U.S. Environmental Protection Agency
EPA Docket Center
Mailcode 2922IT
Attn: Docket ID No. EPA-HQ-OAR-2021-0668
1200 Pennsylvania Avenue, NW
Washington, DC 20460

June 21, 2022

Re: Federal Implementation Plan Addressing Regional Ozone Transport for the 2015 Ozone National Ambient Air Quality Standard, 87 Fed. Reg. 20,036 (Apr. 6, 2022)

Figure 1. Ozone Season NOx Reductions and Costs per Ton (CPT) for Tier 1, Tier 2 Industries, and Other Industries

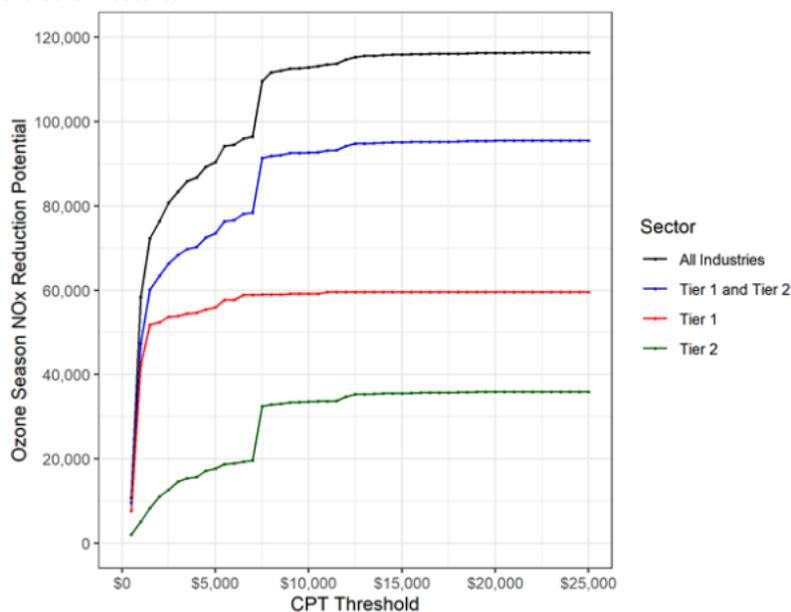
The Proposed Rule provides no explanation of what EPA means by a “knee in the curve” of its cost threshold chart. There is no indication of why such a “knee” would be significant or how it relates to the cost per ton of emission reduction. To the extent that the Proposed Rule meant that \$7,500 per ton is the optimum cost threshold because there is a visible inflection point in the cost-benefit curve, this is not supported by the record. For Tier 1 point sources, which includes Stationary Engines, the Screening Memorandum’s Figure 1 shows no evident “knee in the curve” at, or around, \$7,500 per ton.

EPA, Screening Assessment of Potential Emissions Reductions, Air Quality Impacts, and Costs from Non-EGU Emissions Units for 2026 at 4, Figure 1 (Feb. 28, 2022). Instead, any such “knee” clearly occurs well before \$2,500 per ton, which is consistent with EPA’s determination for the

2021 Revised CSAPR Update Rule using the same Control Strategy Tool. When combined with Tier 2 industries there is a second breakpoint evident in the data at around \$7,500 per ton (with the first breakpoint occurring, again, well short of \$2,500 per ton). This still leaves three significant questions unanswered by the Proposed Rulemaking: (1) What is the justification for establishing a marginal cost threshold for Tier 1 industries by combining them with Tier 2 industry emission control costs instead of using the costs for Tier 1 alone?² (2) Even if using the combined Tier 1 and Tier 2 data, why did EPA disregard the first “knee in the curve” occurring somewhere before \$2,500 per ton and use the second “knee” at or around \$7,500 per ton? (3) Why does the Proposed Rule select a much higher marginal cost threshold than in the 2021 Revised CSAPR Update Rule despite using the same data and the same analytical tools? Without providing an explanation to these questions, the Tier 1 industry marginal cost threshold lacks a rational basis and is unsupported by the record.
